Response to Request for Continuing Examination SN 09/513,768 Bernard E. Souw – Patent Examiner AU 2881

January 15, 2004

The following is a response to Applicant's arguments against the key analysis provided in the Appendix attached to the May 7 Advisory Action.

Fig.1 (from ref.[5])

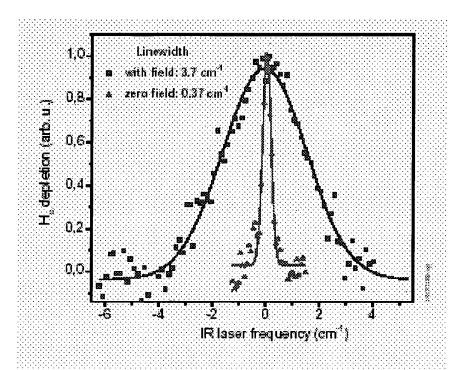
Secondly, and *most importantly*, anomalous hydrogen line broadening is not at all an evidence for the existence of hydrino, because it is well known in the art that such a broadening may be caused by many other conventional mechanisms, such as microwave plasma effects, the latter having not been considered by Applicant. Instead, such an effect has been sofar ignored or dismissed by Applicant without any valid reason. The measured excessive linewidth shown in Applicant's Fig.6 of ref.[6], i.e., 0.27 nm, is about the same magnitude as what is measured by other authors, e.g., ref.[5] cited in the May 7 Appendix, here reproduced in Fig.1 below.

As shown in Fig.[1], the anomalous line width of 0.16 nm, measured in a microwave discharge similar to Applicant's under the same gas mixture and pressure range, is about 10 times the Doppler width, and has been attributed to microwave plasma effects. Applicant's previous criticism on this reference [5] is unjustified. The paper was a conference publication posted by a research group from the University of Essen, Germany. It is not a lone-standing unrefereed paper as alleged by Applicant, but instead, supported by a large number of experimental and theoretical works, as listed at the end of the paper. It would have been extremely doubtful to one of ordinary skill in the art if any cause other than the RF/microwave field itself should be held responsible for an effect that is only and exclusively observed in RF/microwave plasmas.

Thus, Applicant's "excessive line broadening" is not at all an evidence for Applicant's hypothetical "hydrino", but rather, a conventional effect that has been already observed by other authors, as evidenced in Fig.1. Such a high frequency Stark effect has <u>never</u> been considered in any of Applicant's numerous reports on "anomalous" or "excessive" line broadening. Instead, Applicant always assumes that Doppler effect were the main cause, as clearly stated on pp. 6-7 of Applicant's Appendix attached to the RCE. The assumption of Doppler effect as a main mechanism for Applicant's line broadening has been known as incorrect for RF and microwave plasmas, as discussed above. Applicant's misassumption of this line-broadening mechanism automatically disqualifies all Applicant's arguments based on anomalous or excessive line broadening in microwave plasmas.

Applicant's statement on page 6, that "The Examiner does not present any alternative explanation for the cited data", is doubly unpersuasive. Firstly, alternative explanation was readily provided by the result shown in Fig.1, which has been explicitly cited in the previous May 7 Appendix [5].

Fig.2 (from Applicant's recent publication [6] Fig.6)

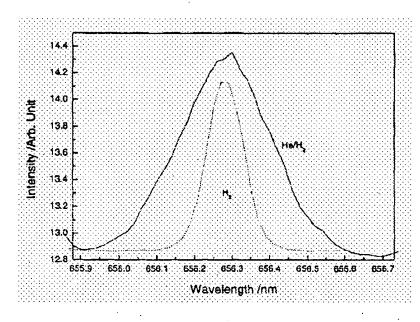
Firstly, Applicant's reports reciting catalytic reaction involving hydrino as the origin for the line broadening observed, are mostly non-refereed publications, as already identified in the previous Office Actions. This also applies to the new references presented in the RCE (see main Office Action). Those published in peer-reviewed journals do not mention "hydrino", or "hydrogen states with fractional energy levels", or anything the like, and therefore, they cannot be considered as "support". In a very few cases, ambiguous term(s) are used by Applicant, so they can neither be considered support for Applicant's hydrino, since what a person of ordinary skill in the art understands under, e.g., "novel catalytic reaction involving atomic hydrogen", or "new kind of plasma" may be anything else but not related to Applicant's "hydrino" as hypothesized in the GUT/CQM. For example, Applicant's most recent reference [6] (RCE ref.(49)) does not recite the word "hydrino", or "hydrogen of fractional energy level", or the

like, nor does it refer to GUT/CQM at all. Consequently, the phenomenon described in such papers must be considered as being completely unrelated to Applicant's invention.
